Response by Michael Brown (IP ref. [REDACTED]) to the SoS's letter dated 4th September 2026
inviting comments from Interested Parties on the Late Response by the Applicant

Outline Residential and Visual Amenity Plan – July 2026 (C1-108)

APPENDIX to paragraph 27 above

Below: Extract from: APP-062 Illustrative Master Plan – Fig. 2.2C

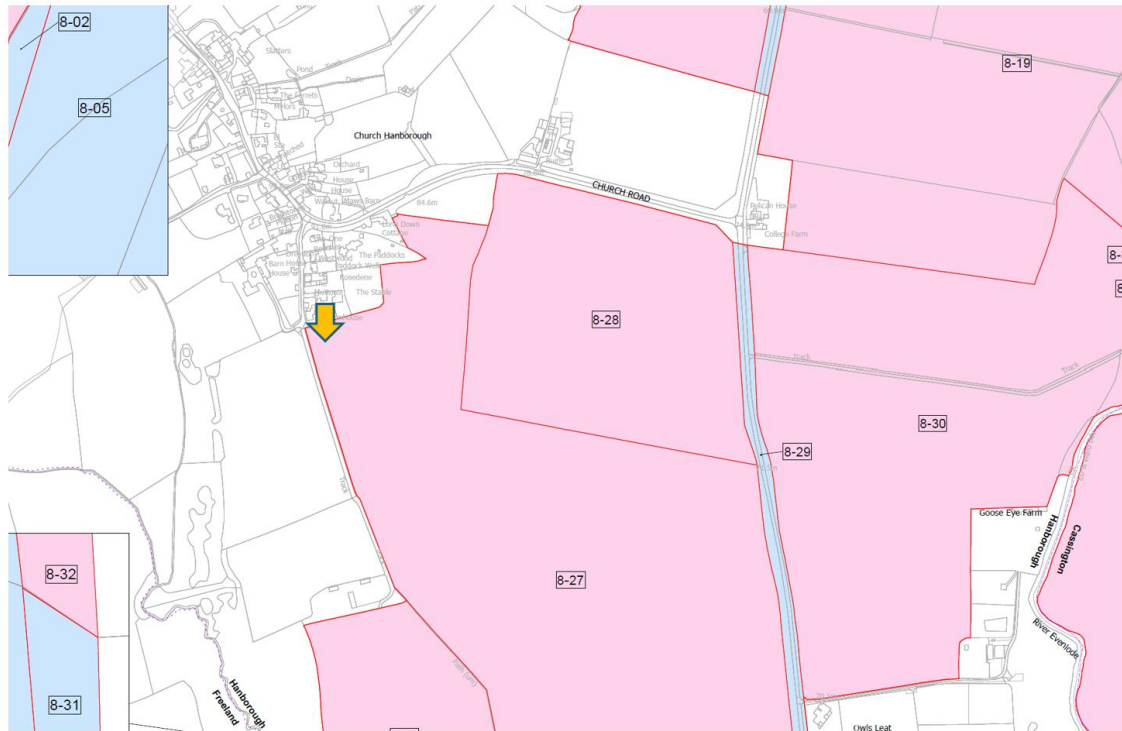
(a) Our home is at the end of an adopted but unnamed lane at the southern end of Church Hanborough. Long distance sightlines from the house and garden are to the south and east. Below please find annotated copies of: two of the Applicant's plans for identification, a photograph looking south from our garden and corresponding photomontage. I am not an expert in photography or montaging so please regard the photomontage as illustrative of the impact from our house and garden. I have tried to take into account the topography. Our house is immediately to the left of the orange arrow on both plans.

Orange arrow ↓ shows location and direction of photo below.

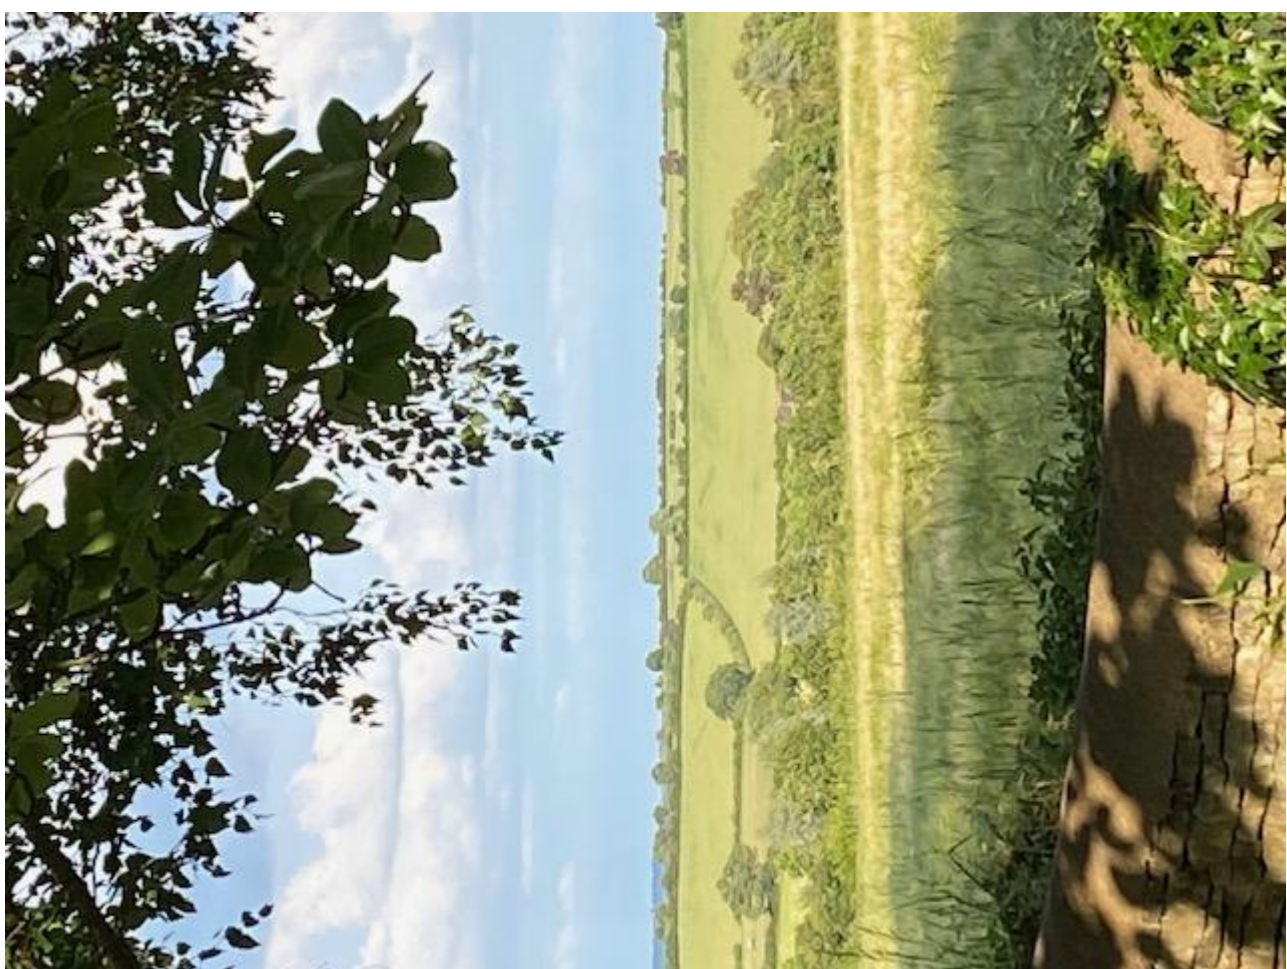
Below: Photo taken June 2025 from back garden of New Barn Farmhouse

Below: Photomontage showing approximate location and height (2.3m) of proposed solar panels. Note that stepladder in photo to right of solar panels is 2.4m high and located at location of edge of panels on footpath estimated from plans on above. Also note that photomontage does not include any proposed fencing.
